W3F1-2004-0075

Subject: Reissue of Report BAW-2177, "Analysis of Capsule W-97 Entergy Operations, Inc. Waterford Generating Station Unit 3 – Reactor Vessel Material Surveillance Program"  
Docket No. 50-382  
License No. NPF-38  
Waterford 3

**Report BAW-2177-01, dated February 2004, "Analysis of Capsule W-97  
Entergy Operations, Inc. Waterford Generating Station Unit 3 – Reactor  
Vessel Material Surveillance Program"**

BAW-2177-01  
February 2004

Figure 5-8. Charpy Impact Data for Irradiated Weld Metal, 88114/0145

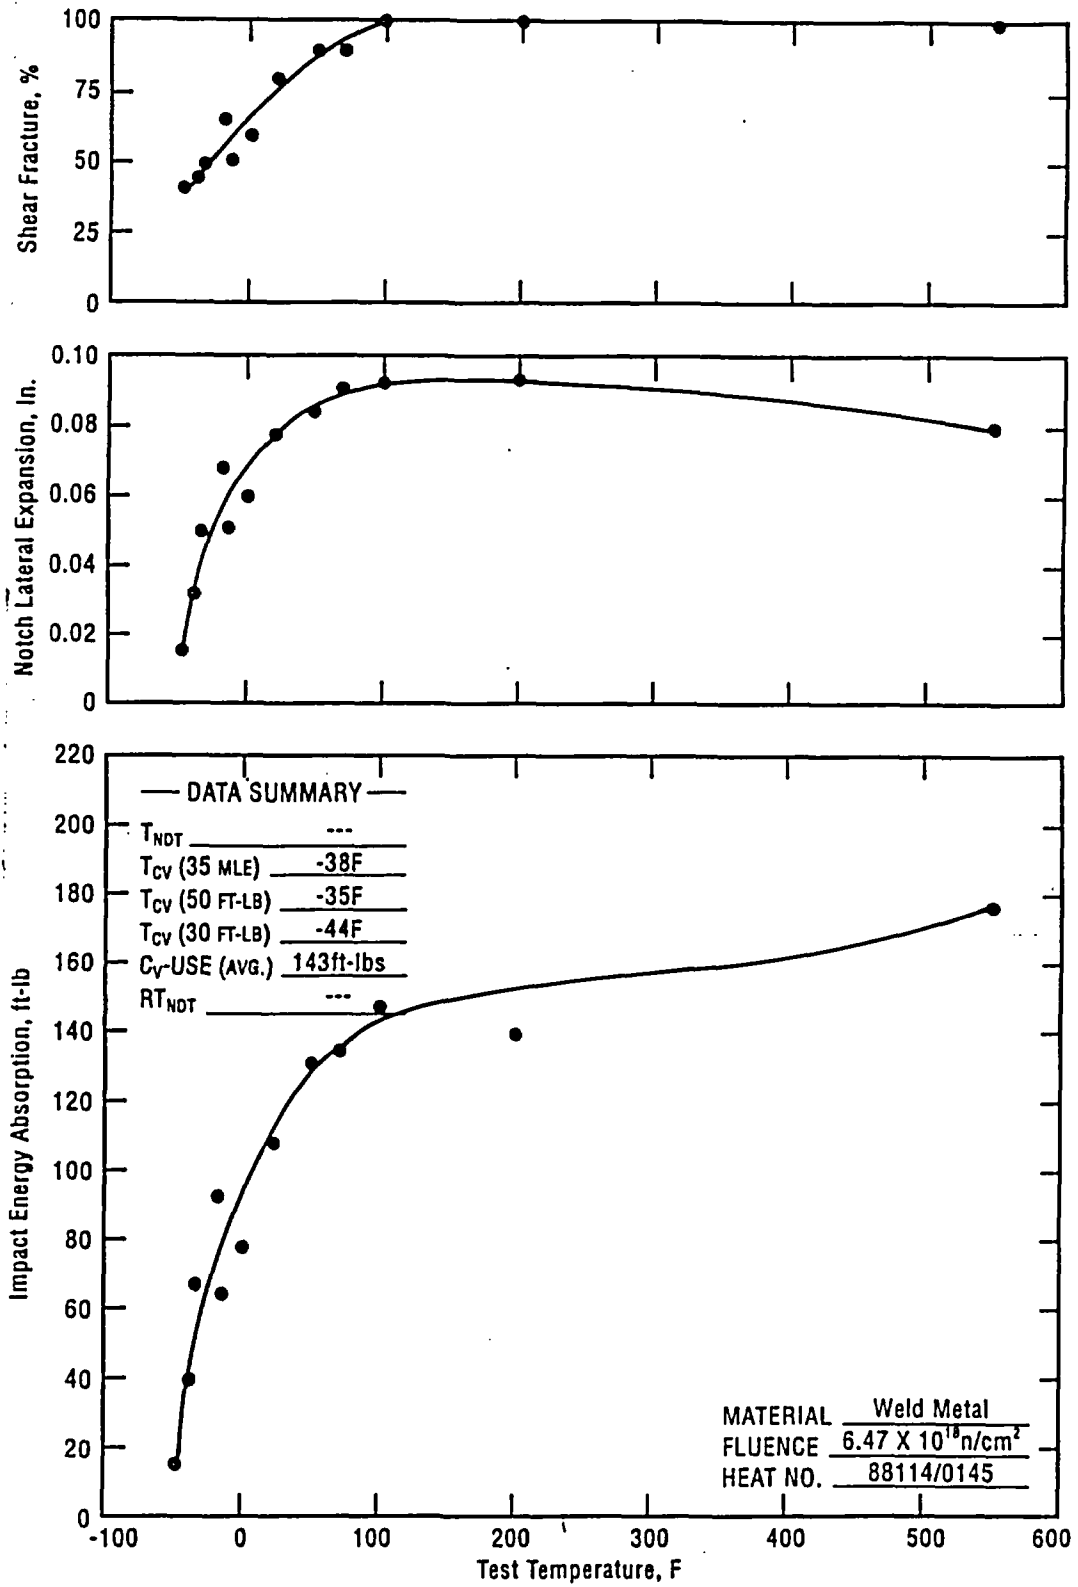
Figure 5-8, "Charpy Impact Data for Irradiated Weld Metal, 88114/0145" had been plotted in Revision 0 using the correct data even though Table 5.6 had incorrect data. A "cut and paste" mistake had occurred from a previous draft.

Figure 7-4. Comparison of Unirradiated and Irradiated Charpy Impact Data Curves for Weld Metal 88114/0145

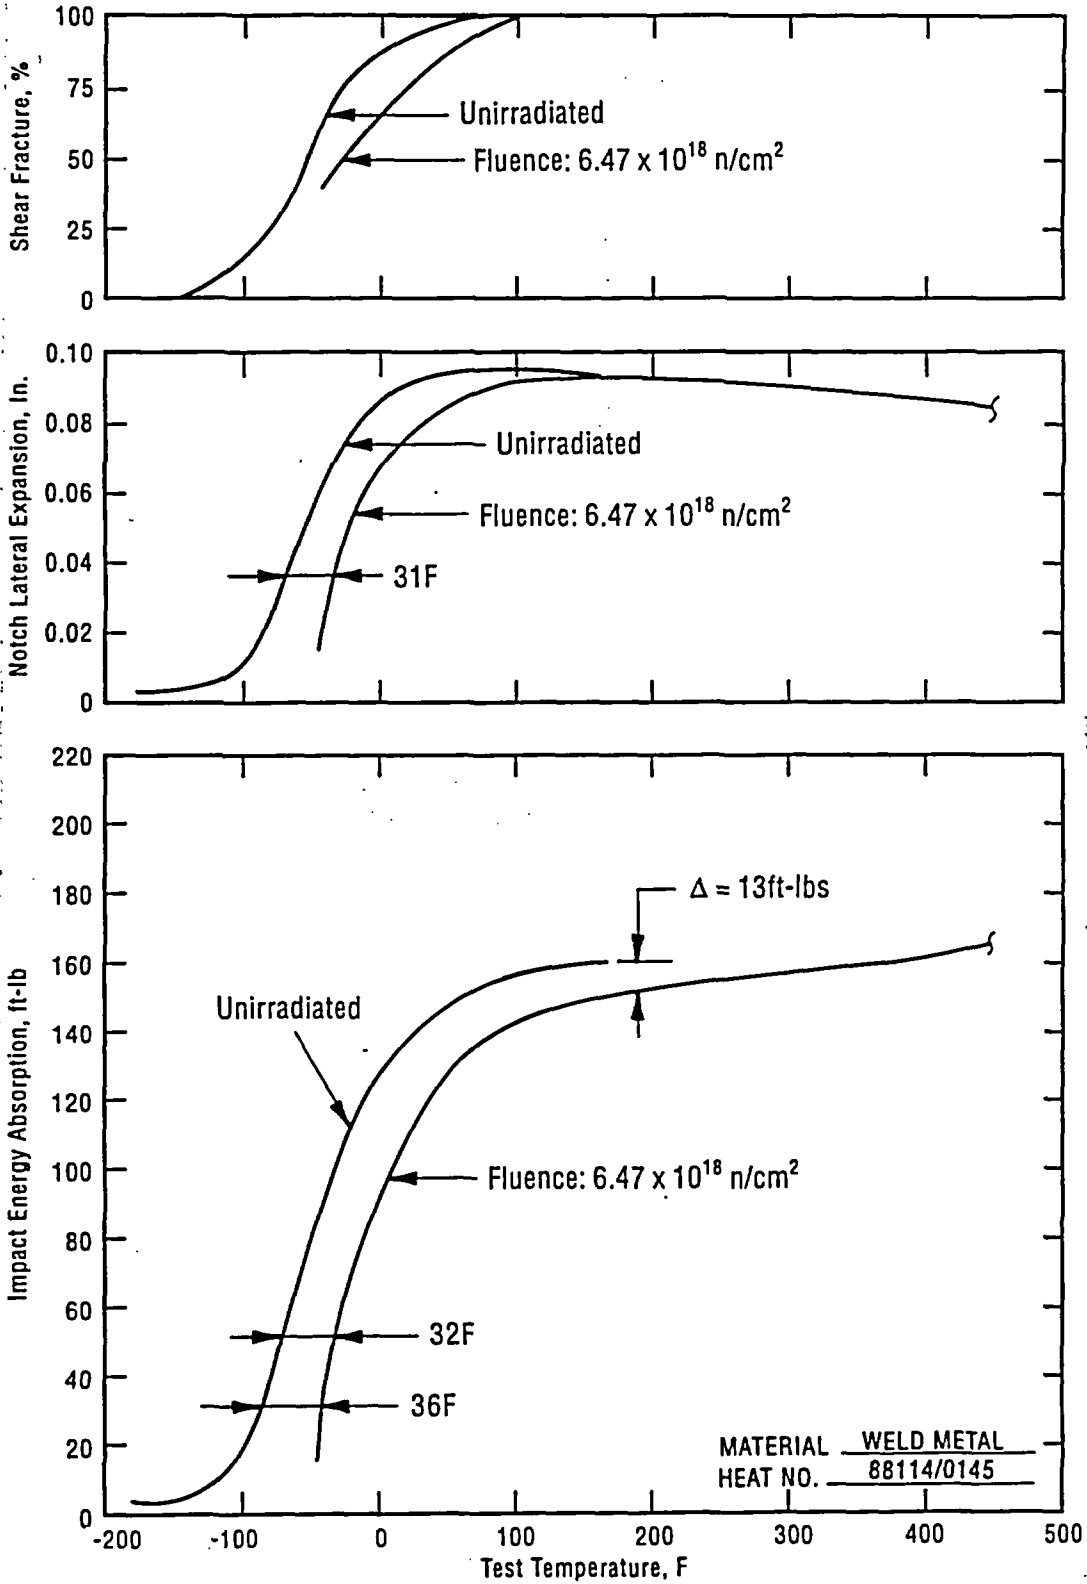
Section 7.0 "Discussion of Capsule Results" and Table 7.3, "Observed vs. Predicted Changes for Capsule W-97 Irradiated Charpy Impact Properties –  $6.47 \times 10^{18}$  n/cm<sup>2</sup> (E > 1 MEV)" used the correct data from Figure 5-8 for the comparison of observed vs. predicted property changes. Since the actual numbers used in the comparison of the transition temperature and upper shelf energy changes are correct, the conclusions that the calculated property changes are conservative relative to the observed properties therefore remain unchanged.

In summary, the error in Table 5.6 of report BAW-2177 has no impact on the conclusions contained in the report. The calculated reactor vessel material properties remain conservative in relation to the observed, via specimen testing, material properties.
